Re: ACP-323635-25 Strategic Infrastructure Development - Proposed development of 9 no. wind turbines, grid connection and all associated site works. Located in the townlands of Garrane, Ballynagoul, Creggane and Charleville, Co. Limerick.

**DIRECTOR GENERAL'S REPORT IN ACCORDANCE WITH THE
REQUIREMENTS OF SECTION 37E (4) OF THE PLANNING AND
DEVELOPMENT ACT 2000 (AS AMENDED) IN RELATION TO GARRANE
WINDFARM**

ACP REFERENCE: PAX91.323635

Figure 6 HES (2017)'s Figure 1 proposed pipe route conveying wastewater from Kerry Ingredients WWTP for discharge to the River Maigue at the proposed Garrane Wind Farm.

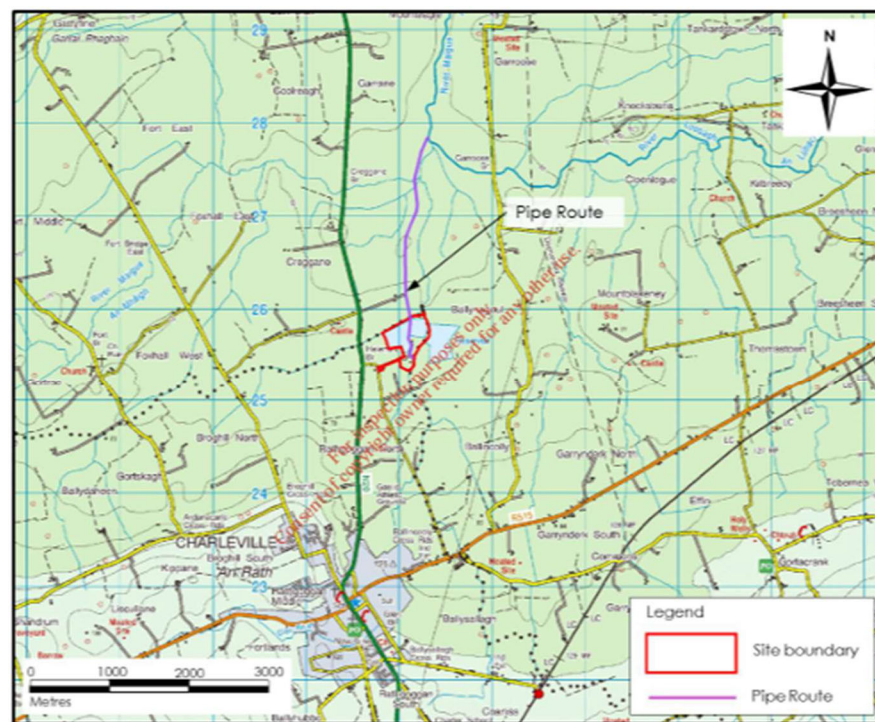
The same authors of the proposed Garrane Wind Farm Flood Risk Assessment completed a Flood Risk Assessment in 2017 for Kerry Ingredients (Ireland) site at Charleville with respect to a proposed pipeline discharging to the River Maigue. The wastewater discharge pipeline route proposed from the Kerry Ingredient’s Charleville site’s WWTP was presented as Figure 1 in the HES 2017 report entitled ‘WWTP FLOOD RISK ASSESSMENT RATHGOGGAN NORTH SITE’. The Commission is advised that the pipeline route traverses the proposed Garrane Wind Farm site and might discharge treated effluent to the River

Maigue in the wind farm site. The Commission is requested to assess this issue. Does it Matter? Yes, it does. Why does it matter: pollution potential, tipping point pressure potential, in combination pressures, omissions in EIA, incomplete application details. Figure 1 of the HES (2017) report is shown here as Figure 6.

Figure 7 EPA Envision 3rd Cycle At Risk mapping for the Charleville Stream and Mague River in the vicinity of the proposed Garrane Windfarm.

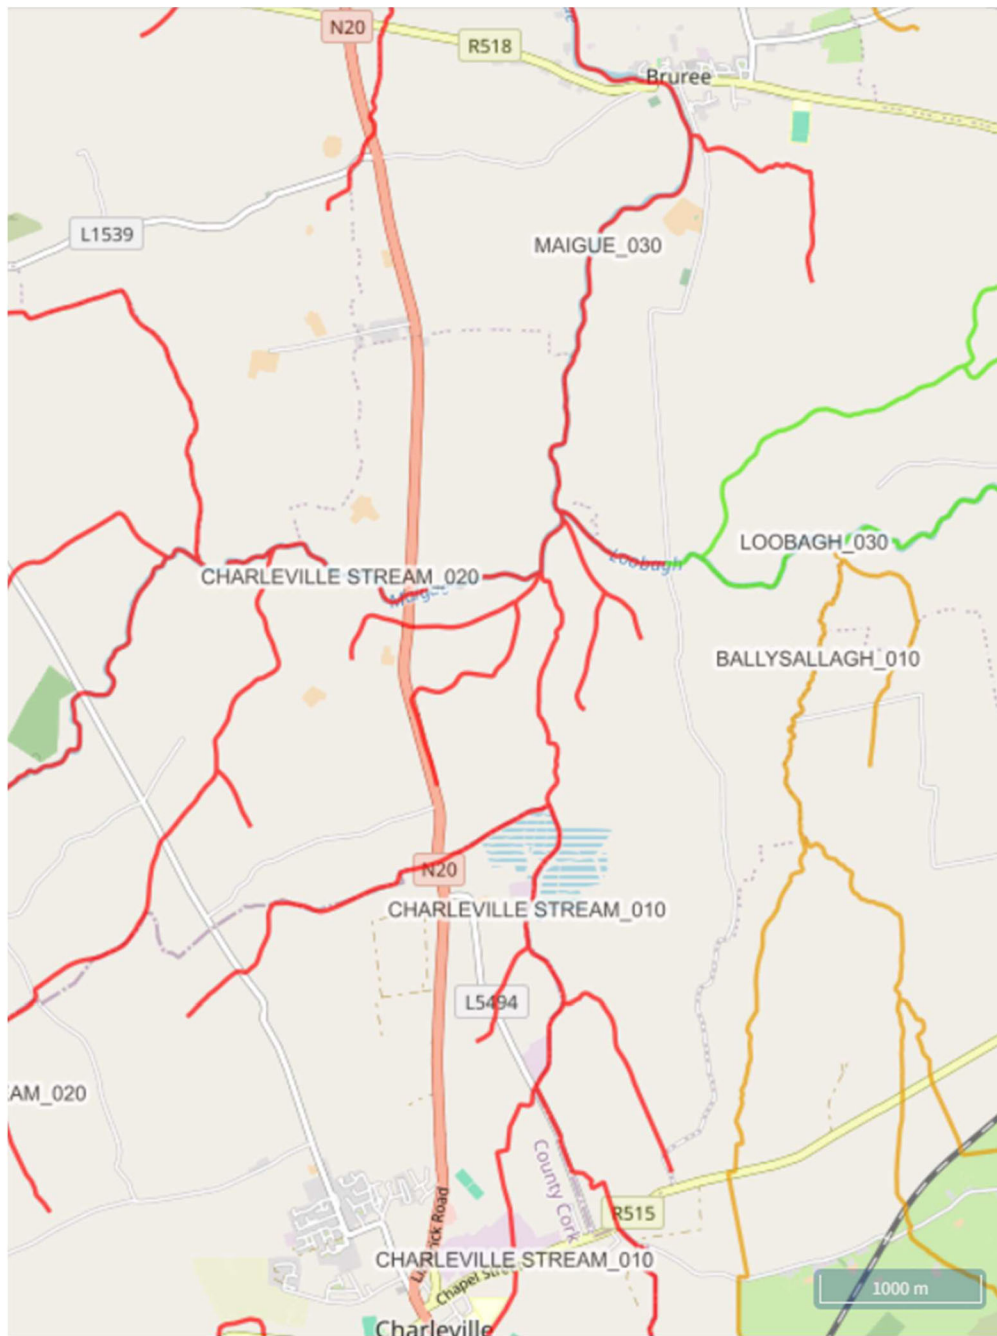
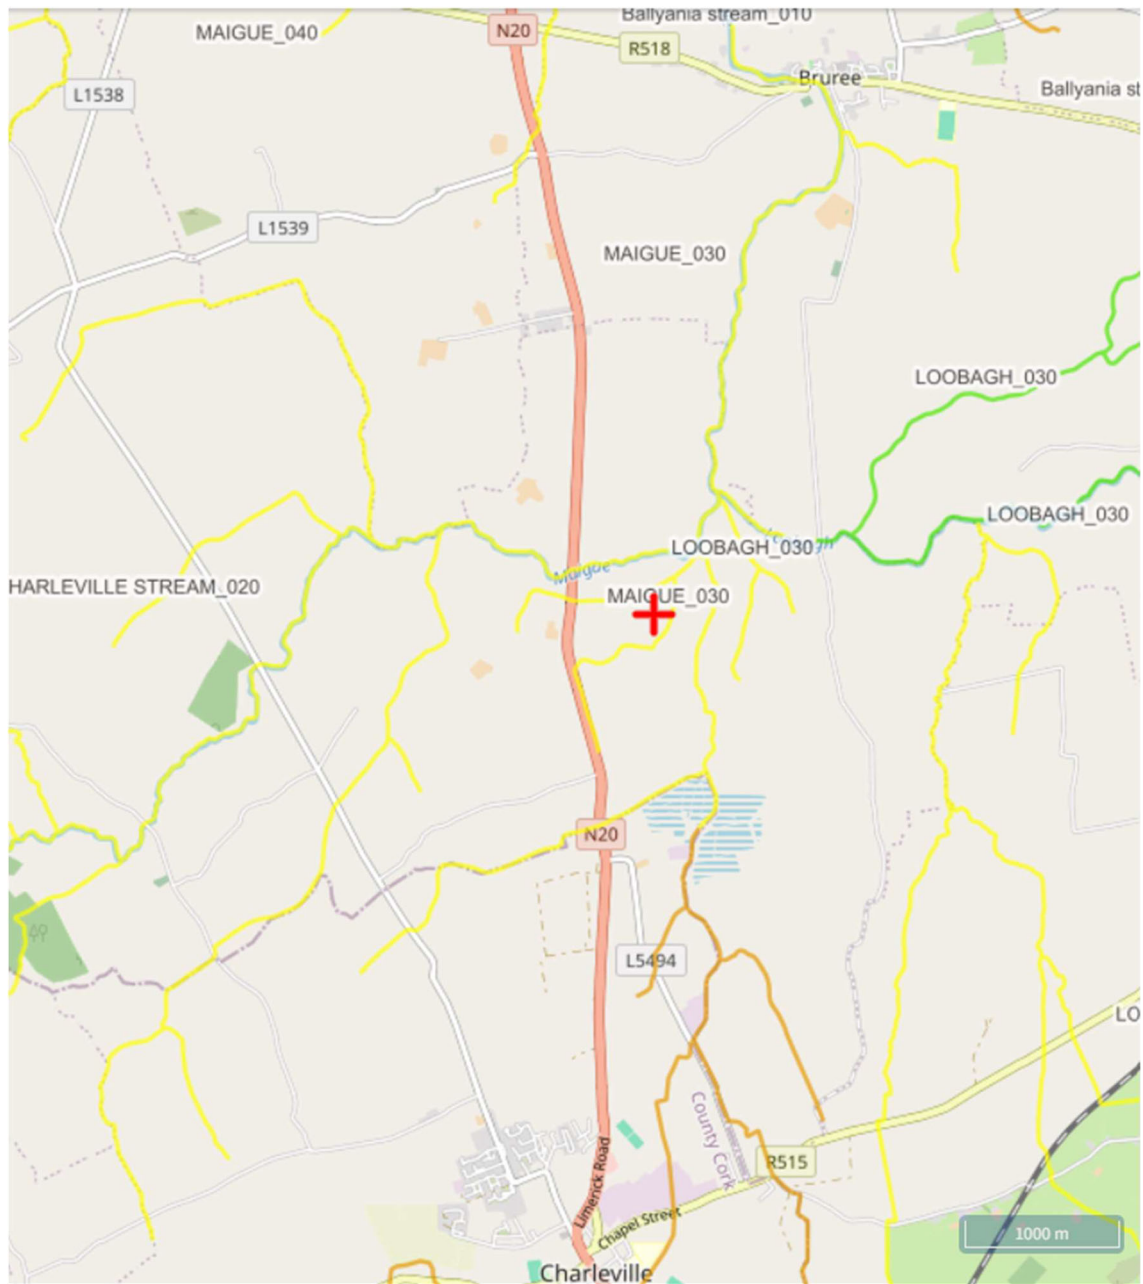
The Commission is requested to enquire with the EPA as to the status / functionality of the wastewater discharge pipeline discharging from the Kerry Ingredients Plant at Charleville to the River Maigue at Creggane and Garrane. Extracts from the Industrial Emissions Licence for the Kerry Ingredients facility seem to detail that the discharge is operational. Extract from the IE Licence is provided as shown in Plates A & B. The referenced Charleville Stream and Maigue Rivers are shown in Figures 7 & 8.

As previously stated, none of the rivers in the proposed development site are meeting their WFD Objectives and the EPA published deadline is 2027 – just over one year away. The rivers are all mapped as 3rd Cycle At Risk and Moderate Status (2019 – 2025). Whilst construction is not a reported pressure or issue at the moment, that does not mean that construction is viable or defensible either.
